30-045-25933 CARSON UNIT #024

DJR OPERATING, LLC

DJR Operating, LLC requests permission to Plug & Abandon the subject well accorded to the attached Procedure, Current & Proposed Wellbore Diagram and Reclamation Plan.

Re: Permanent Abandonment
Well: Carson Unit 15 24

Proposed Wellbore P&A Diagram
DJR Operating, LLC
Carson Unit 15 24
 API # 30-045-25933
 SE/SW, Unit N, Sec 15, T24N, R12W
 San Juan County, NM

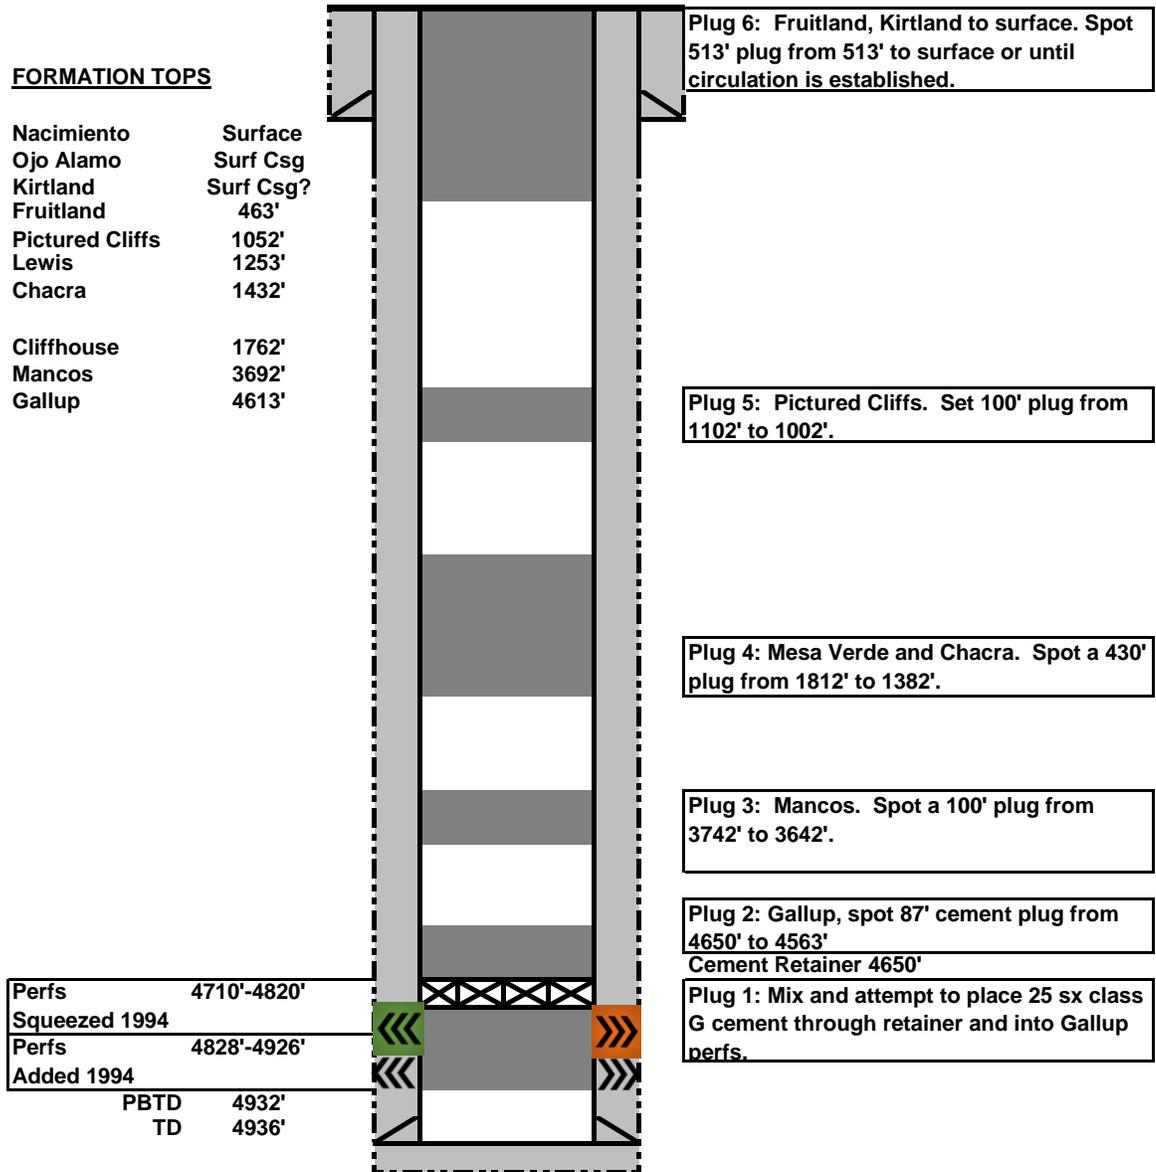
- Notify NMOCD 24 Hours prior to commencing activities
- In addition to the BLM approved plugs
- Include a plug 670'-500.' OCD Fruitland pick @ 620, BLM pick @ 550.'
- Include plug 2140-2040. OCD Mesa Verde pick @ 2090.'
- Ensure Chacra is covered, 1482-1382.'

- Please ensure that the tops of the Pictured Cliffs, and Fruitland formations, as well as the entire Ojo Alamo aquifer, identified in this report, are isolated by proper placement of cement plugs. This will protect the freshwater sands in this well bore.

- Please note that the BLM geologist's pick for the Cliff House formation varies significantly from the operator's pick. In addition, the top of the Fruitland formation varies slightly from the operator's pick. Lastly, the Lewis shale is encountered twice, above and below the Chacra.

1. Plugging operations authorized are subject to the attached "General Requirements for Permanent Abandonment of Wells on Federal and Indian Lease."
2. Farmington Office is to be notified at least 24 hours before the plugging operations commence (505) 564-7750.
3. BLM tops are based on the attached geologic report. Ensure all plugs cover 50 feet above and below indicated formation tops with plugs meeting General requirements. Minimum inside plug to include 50' excess cement. Minimum inside plug 18 sacks class g cement. See attached BLM geologic report.
 - a. BLM picks Cliffhouse formation top at 2160'. Spot an additional Plug to cover 2110 – 2210.
 - b. BLM picks Fruitland formation top at 550'. Extend surface plug to 600' md.
